Item Name: Quick Release Basket and Long Cargo Tube Mounting Provisions, Fits LH or RH

DART SERVICE INSTRUCTION

TO AMEND INSTALLATION INSTRUCTIONS D350-607-3 Rev.D,
INSTALLATION INSTRUCTIONS D350-607-4 Rev. C AND
INSTRUCTIONS FOR CONTINUED AIRWORTHINESS ICA-D350-607 REV. 6
REF TCCA STC: SH94-14
REF FAA STC: SR00213NY
REF EASA STC: EASA.10016996
REF BRAZILIAN STC: 2007S03-03/-04/-05/-06

A	NEW ISSUE	AJS	14.05.16
REV.	DESCRIPTION	BY	DATE
DESIGN	AJS	DART AEROSPACE LTD HAWKESBURY, ONTARIO, CANADA	
DRAWN	AJS		
CHECKED	N/A	DRAWING NO.	REV. A
MFG. APPR.		DSI 9699	SHEET 1 OF 2
APPROVED		TITLE	SCALE
DE APPR.		LUG REPLACEMENT	NTS
DATE	14.05.16	COPYRIGHT © 2014 BY DART AEROSPACE LTD THIS DOCUMENT IS PRIVATE AND CONFIDENTIAL AND IS SUPPLIED ON THE EXPRESS CONDITION THAT IT IS NOT TO BE USED FOR ANY PURPOSE OR COPIED OR COMMUNICATED TO ANY OTHER PERSON WITHOUT WRITTEN PERMISSION FROM DART AEROSPACE LTD.

FIGURE 1: INSTALLATION OF D4775-041 FWD STRUT

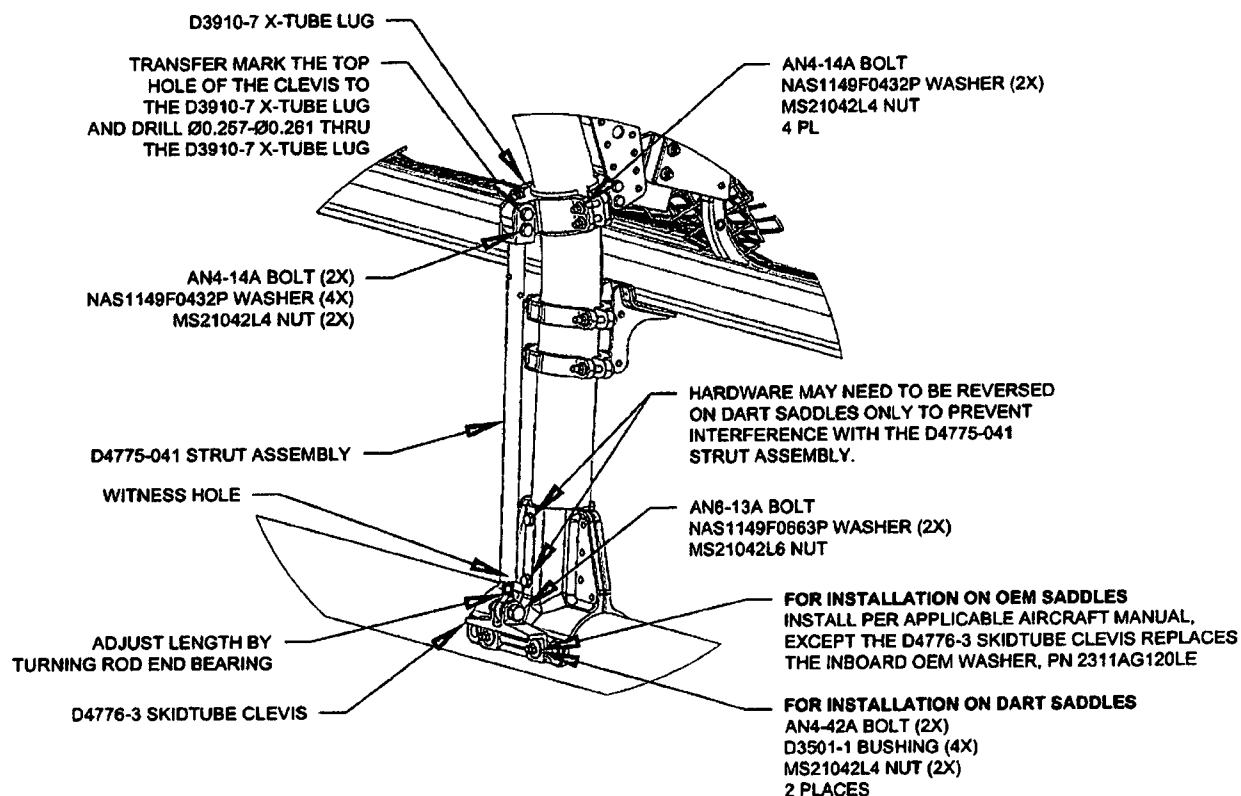
3.1 Substitute the Forward Lower D3910-5 X-Tube Lug with the D3910-7 X-Tube Lug as shown in Figure 1.

3.2 Install the forward D4775-041 Strut Assembly. Transfer mark from the upper hole on the clevis of the D4775-041 Strut Assembly to the D3910-7 X-tube Lug and drill thru the lug $\varnothing 0.257$ - $\varnothing 0.261$ as shown in Figure 1. Touch up chemical conversion coating per MIL-DTL-5541. Check the witness holes located at the bottom end of the D4775-041 Strut Assemblies to ensure that the thread from the rod end extends past the witness hole.
Torque MS21042L4/-4 nuts to 50-70 in-lbs (5.7-7.9 N-m). Torque MS21042L6/-6 nuts to 160-190 in-lbs (18.1-21.5 N-m).
